URGENT FIELD SAFETY NOTICE

FSCA Reference: 1427918 - Bubble Sensor - Bad contact in sensor cable

Affected Product: BS 3/8x3/32 L1.7 Mat. 701055720
(Bubble Sensor for 3/8" x 3/32" tubing, length 1,7 m)

Figure 1 Picture of a Venous Bubble Sensor

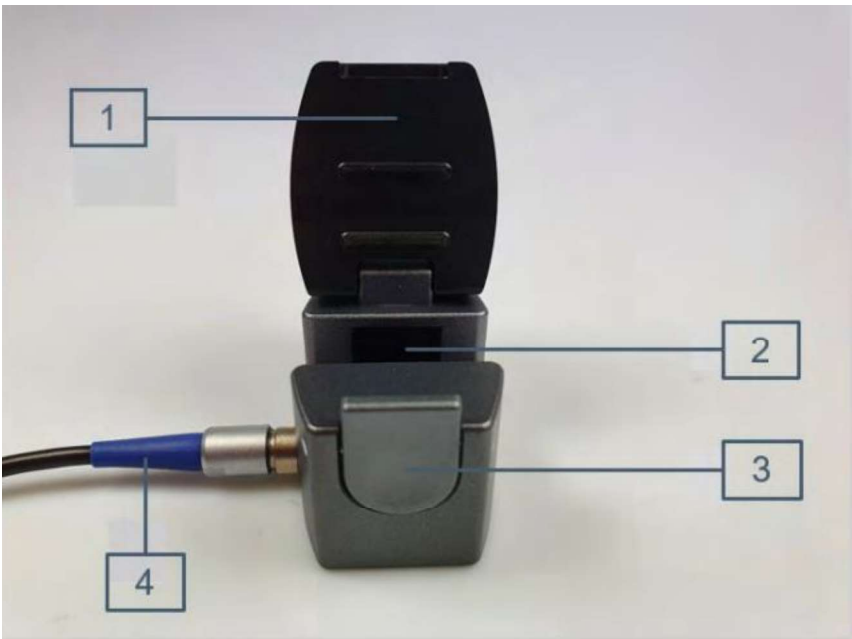
Internal investigations have identified an issue with the durability of the connecting cable (See Fig. 1 position [4]) near the connection to the Bubble Sensor. Excessive bending of the cable can lead to poor contact, which may trigger the errors “Ven. bubble sensor defective” or “Ven. bubble sensor disconnected” on the connected medical device (ROTAFLOW II or CARDIOHELP-i). These errors can occur temporarily when the cable is moved or permanently if the connection is fully compromised.

- **The Venous Bubble Sensor remains functional until error** (“Ven. bubble sensor defective” or “Ven. bubble sensor disconnected”) displays on the main device.
- **To prevent error occurrence please follow these guidelines when handling Venous Bubble Sensors:**
 1. **Avoid roll up or coiling of the sensor cable!** When storing affected products, place them loosely in a box or bag to prevent damage.
 2. **Avoid excessive bending** of the Venous Bubble Sensor.
 3. **Handle the Sensor cable with care during cleaning.** Do not pull with excessive force while wiping the cable.

Replacement of affected with unaffected devices.
